DFW B707-53-509 MLG W.W. BS 960 FAIRING ACCESS PANEL MODIFICATION

LH MLG W/W/ BS 960 FAIRING ACCESS PANEL MODIFICATION

ENGINEERING INSTRUCTION	Ref.: DWF B707-53-509 Revision: ATA chap.: 53 Date: 15 Jan.2007 Page: 13 of 14
--	--------------------------------	--

**Fig.1
BS 960 Fairing Access Door Instl.**

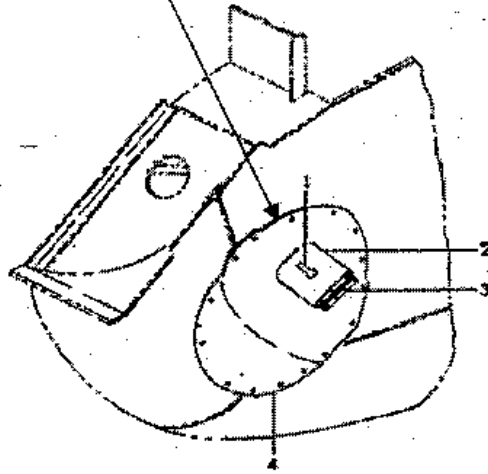
- Remove existing LH side Round Cover Assy's shown in Fig.1 (Ref. IPB 53-07-7 item 8).
Note : *location of the Screws and retain them for reinstallation. Visually inspect nutplates installed along the cutout for general conditions and replace as required per SRM 51 -2-2.*

- Manufacture 2ea. Fairing Covers out of a sheet from 2024T3 AlClad 0.040 in.thk. per SAE AMS QQ-A-2506.
Shape new Fairing Covers as the removed ones except for the latch door cutout that need not be performed. See Fig.1 item 4.
Follow BAC5300 requirements when shaping and forming aluminum sheet. Anodize Fairing Covers per MIL-A-8625 and apply 2ea. coats of MIL-PRF- 23377 epoxy primer per MM 51-90-00.
Identify Covers as PIN DWF-B707-53-509-1 for the LH side.

- As an option to the repair per step 2 above, the fairing assy can be reworked by removing and scrapping the latch door and the internal cutout doubler (see Fig.1 items 2 and 3) and a new internal doubler can be manufactured and installed according to SRM 51 -1 4-2 Fig. 1 requirements.

MAINT	RII/INSP
<u>RH MLG W/W/ BS 960 FAIRING ACCESS PANEL MODIFICATION</u>		
<u>Modification instructions</u>		
1. Remove existing RH side Round Cover Assy's shown in Fig.1 (Ref. IPB 53-07-7 item 8).		
<u>Note :</u> <i>location of the Screws and retain them for reinstallation.</i> <i>Visually inspect nutplates installed along the cutout for general conditions and replace as required per SRM 51 -2-2.</i>

2. Manufacture 2ea. Fairing Covers out of a sheet from 2024T3 AlClad 0.040 in.thk. per SAE AMS QQ-A-2506. Shape new Fairing Covers as the removed ones except for the latch door cutout that need not be performed. See Fig.1 item 4. Follow BAC5300 requirements when shaping and forming aluminum sheet. Anodize Fairing Covers per MIL-A-8625 and apply 2ea. coats of MIL-PRF- 23377 epoxy primer per MM 51-90-00. Identify Covers as PIN DWF-B707-53-509-2 for the RH side.

3. As an option to the repair per step 2 above, the fairing assy can be reworked by removing and scrapping the latch door and the internal cutout doubler (see Fig.1 items 2 and 3) and a new internal doubler can be manufactured and installed according to SRM 51 -1 4-2 Fig. 1 requirements.

**Cover Assy to be replaced
by a Blank Panel per Step 2
or
Reworked per Step 3.**
